RESPONSE TO REQUEST FOR ADDITIONAL INFORMATION

APR1400 Design Certification

Docket No. 52-046

RAI No.: 274-8277
SRP Section: 07.01 – Instrumentation and Controls – Introduction
Application Section: 07.01, 07.03, and 10.2
Date of RAI Issue: 10/27/2015

Figure 7.2-14 Plant Protection System Interface Logic Diagram for Division D

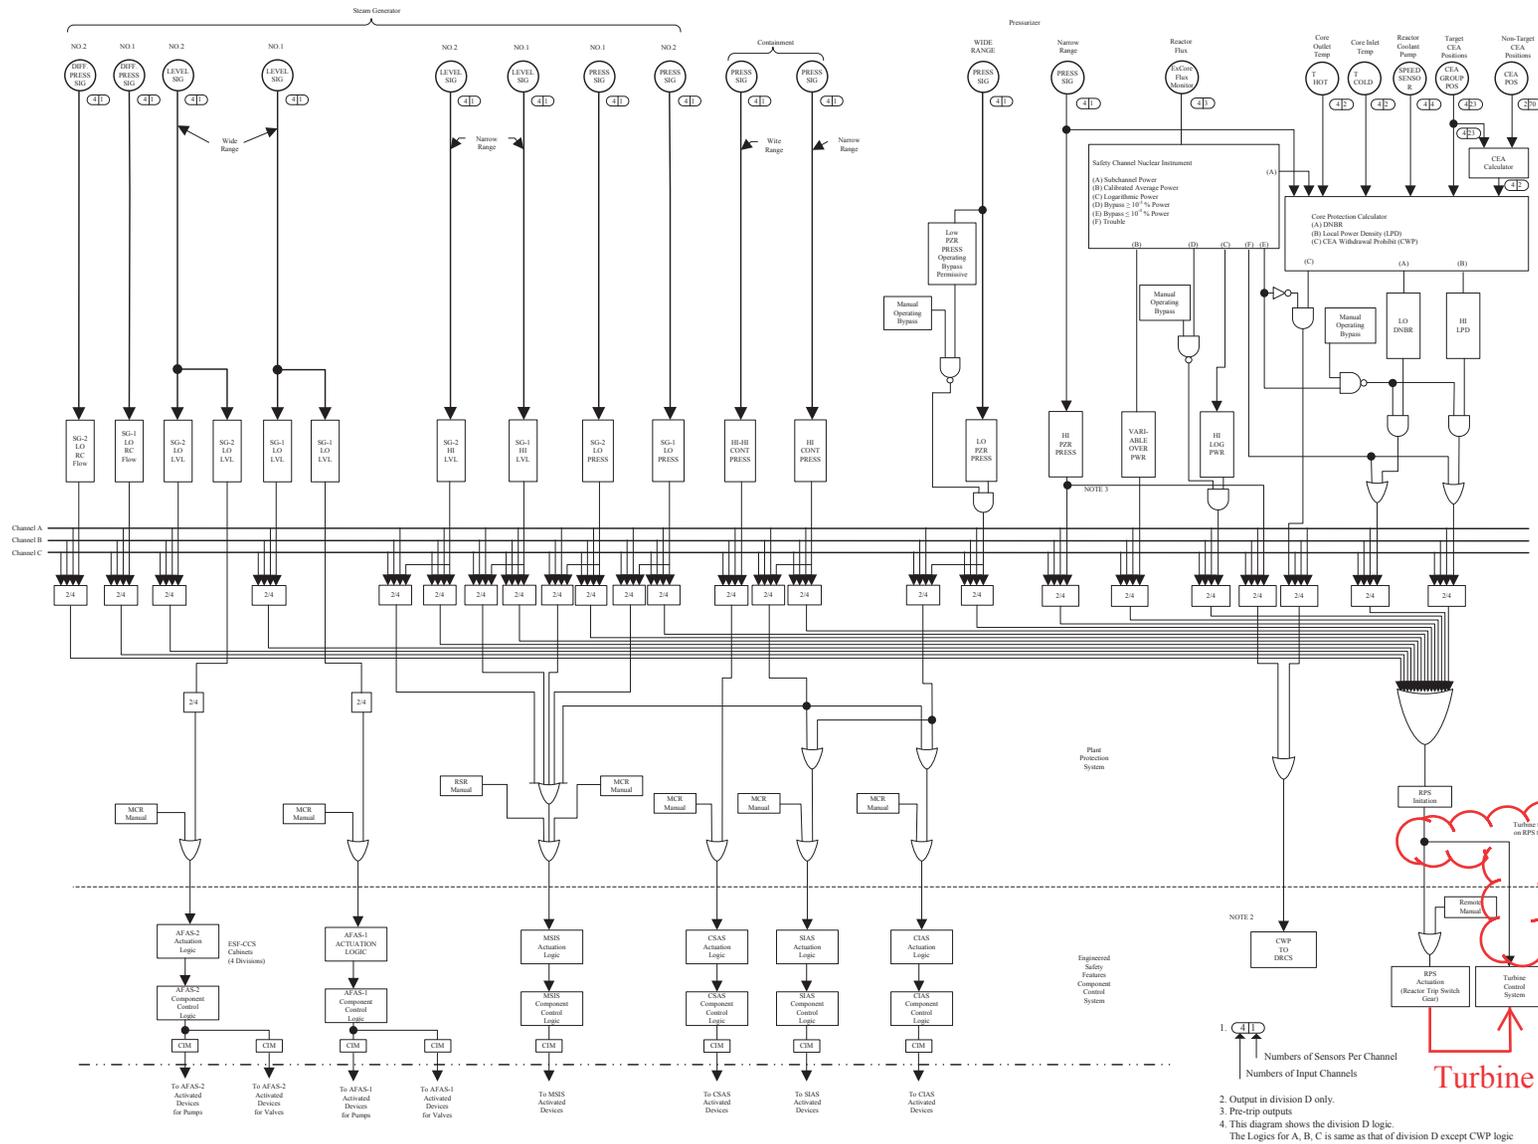
2. APR1400 FSAR Tier 2, Figure 7.2-14, only shows the PPS system interface logic diagram for Division D. It is unclear to the staff whether the interfaces depicted in this figure also apply to the other three PPS divisions. Clarify in the APR1400 FSAR whether this figure applies to the other PPS divisions. If there are differences between these interfaces for different divisions, provide a description of the differences in the APR1400 FSAR.

3. APR1400 FSAR Tier 2, Section 10.2.2.3.3, states that each trip input is applied to a triple redundant protection module, where 2-out-of-3 majority voting is conducted within the protection system where possible to prevent spurious turbine trips and enhance protection system operation on an actual turbine trip. The turbine includes instrumentation for a trip on excess vibration and a remote trip input signal from the plant control system on a reactor trip. Since there are four divisions of PPS, and the turbine protection system only has triple redundancy, how does each PPS division interface with the turbine protection system to produce a turbine trip? Provide this information in the APR1400 FSAR.

2. Notes 2 and 4 on the bottom right of Figure 7.2-14 are already provided. The notes indicate the figure applies to all PPS divisions except for the CWP implementation.
3. The "2-out-of-3 majority voting" logic stated in APR1400 FSAR, Tier 2, Section 10.2.2.3.3 is dedicated logic within the turbine control system (TCS) to generate the turbine trip signal during the system abnormal condition (e.g., generator stator wind coolant low flow, generator stator inlet water low pressure). This 2-out-of-3 voting logic does not use the signal from the 2-out-of-4 voting logic implemented in the plant protection system (PPS).

For turbine trip, each PPS division interfaces with the TCS as follows:

Two (2) sets of contact signals are provided per division in the reactor trip switchgear system (RTSS). A total of eight (8) output signals are generated. The contact signal, as a momentary signal type, is provided through hardwired connections. Isolation is achieved by using Class 1E isolation relays within the RTSS.

The two sets of contact signals from each division in the RTSS are inputted to two P-CCS cabinets through hardwired connections. The P-CCS cabinets have 2-out-of-4 voting logic to prevent spurious turbine trip due to single P-CCS cabinet failure. The results of the 2-out-of-4 voting logic in the P-CCS cabinets are provided to the TCS to initiate turbine trip.

Section 7.2.1.4 and Figure 7.2-14 of DCD Tier 2 will be revised to include the above information.
